**Metropolitan St. Louis
Sewer District**

RE: Proposed Non-Material Modifications of CSO Control Measure Design Criteria:

Proposed Non-Material Modification of CSO Control Measures: In-Sewer Storage Upstream of Lemay CSO Outfall 063 AND Lower & Middle River Des Peres Storage Tunnel

Proposed Non-Material Modification of CSO Control Measures: Upper River Des Peres Storage Tunnel, River Des Peres Tributaries Storage Tunnel, AND Lower & Middle River Des Peres Storage Tunnel

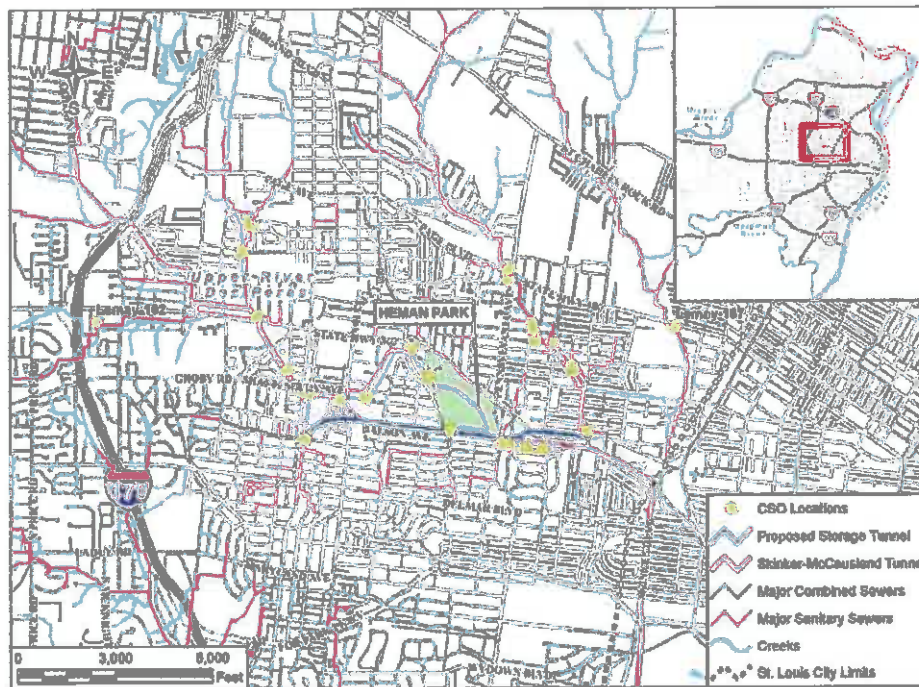
At the ending of the Design Criteria description for each of the listed CSO Control Measures, the following wording was added: “...to capture flows from Lemay CSO Outfalls [followed by a listing of each CSO Outfall].” This wording was added to the Consent Decree during the very last minutes of negotiations (May 27, 2011) as the final change to the Consent Decree before execution.

MSD believes that this wording could be interpreted as requiring each and every one of the named CSO Outfalls to be physically connected to the storage tunnel. MSD asserts that this was not the intent of the LTCP or Consent Decree negotiations, wherein it was recognized that other means that reflect good engineering practice or provide greater environmental benefit could be used to meet the Performance Criteria, such as partial or complete sewer separation, elimination

MSD proposes that the Design Criteria for each of these three Control Measures be modified and clarified by deleting the wording as indicated on the attached pages.

River Des Peres Tributaries CSO Controls

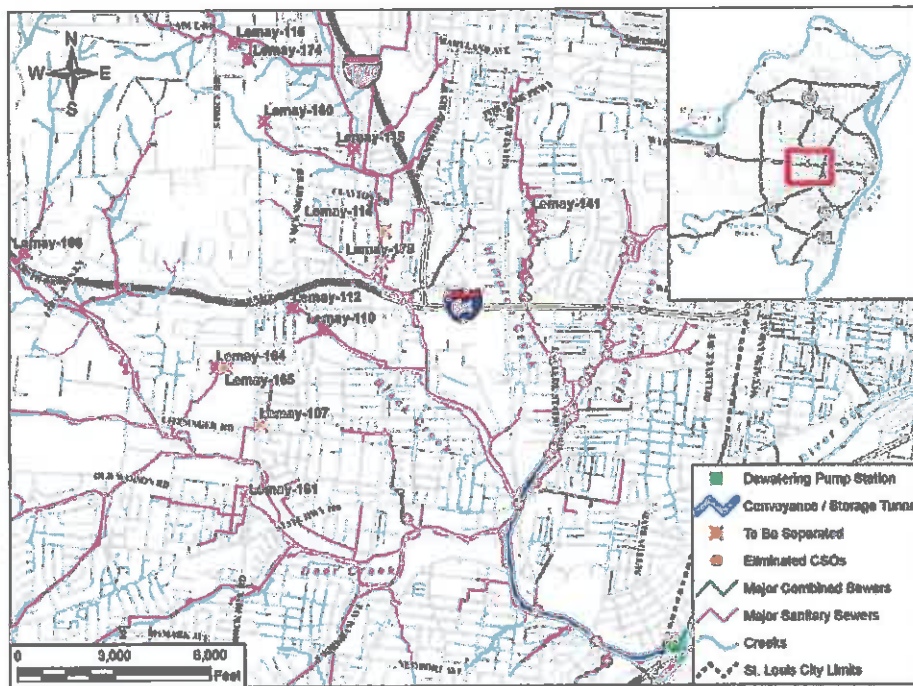
CSO Control Measure	Description	Design Criteria	Performance Criteria	Critical Milestones
River Des Peres Tributaries Storage Tunnel serving Lemay CSO Outfalls 103, 104, 105, 106, 111, 117 to 128, 130, 131, 134, 136 to 140, 166 and 176	Storage / conveyance tunnel, near-surface facilities, pump station, sewer separation and consolidation sewers	Conveyance tunnel with storage volume of 28 million gallons to capture flows from Lemay CSO Outfalls 103, 104, 105, 106, 111, 117 to 128, 130, 131, 134, 136 to 140, 166 and 176	When incorporated with other River Des Peres CSO controls, reduce overflows to 4 events or less to River Des Peres main channel in the typical year ⁽¹⁾	<ul style="list-style-type: none"> • Bid Year – 2024 • Achievement of Full Operation – 06/30/2030

——— Modifications proposed in this request
